## COMMISSION FOR HISTORICAL & ARCHITECTURAL PRESERVATION

### STAFF REPORT

**REQUEST:** Concept Review – Construct Seven-Story Building

**ADDRESS:** 1208-1226 E. Baltimore Street (Jonestown Historic District)

Image 9: 1208-1228 E. Baltimore, proposed design in streetscape, May 18, 2018

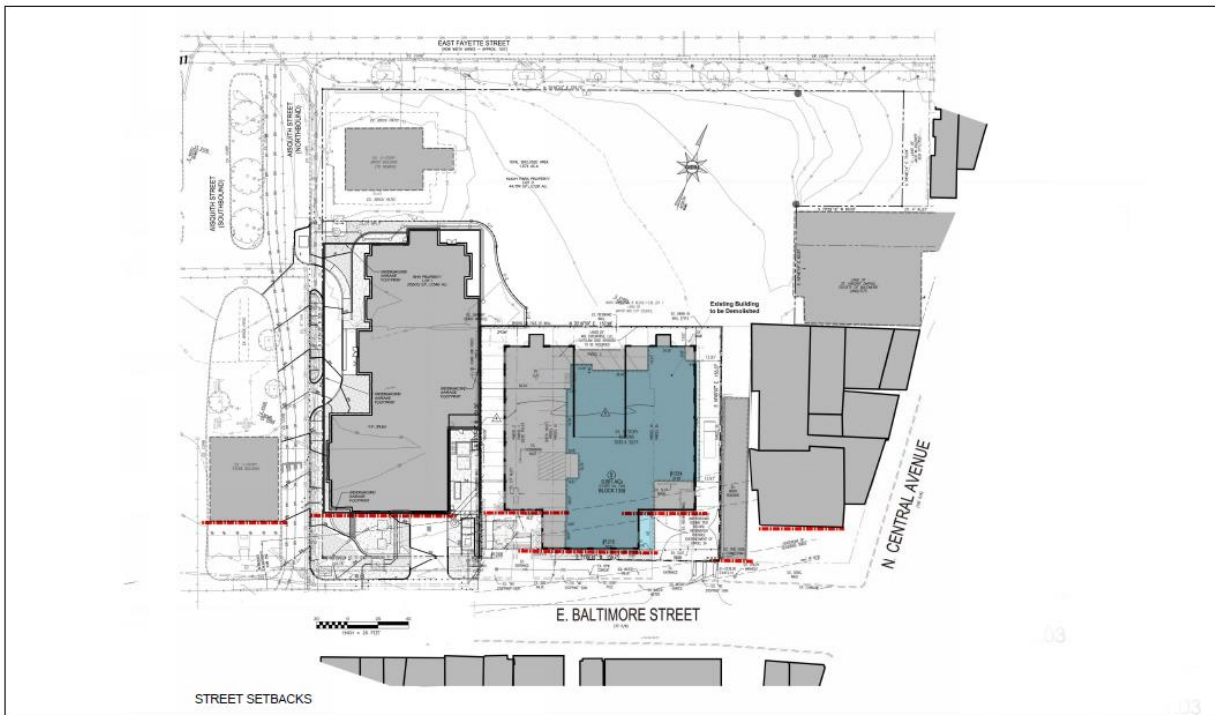
- *2.3 Scale and Form:* The proposed building is large, driven, according to the applicant, by the building program and by the realities of the Metro encroachments below ground. The proposed building is 91'-0" to the terrace roof. As point of comparison, the neighboring Ronald McDonald House is 81'-10". The new construction of the proposed Hendler development farther to the west will be about 81'-6" at the parapet edge. Staff recommends looking at setting back the rooftop deck and roof overhang to lessen the perceived height of the building. The mass is essentially broken into three pieces, with a central section at the sidewalk and two wings set back about 25'-0" on each side. The building wings differ in width, with one setback wing two bays wide and the other three bays wide, creating some more visual interest than a purely symmetrical form. With the construction of this project, the north side of E. Baltimore Street will take on another building of a larger scale, and the lower scale of the south side of the street remains intact. The plan meets the design guideline.
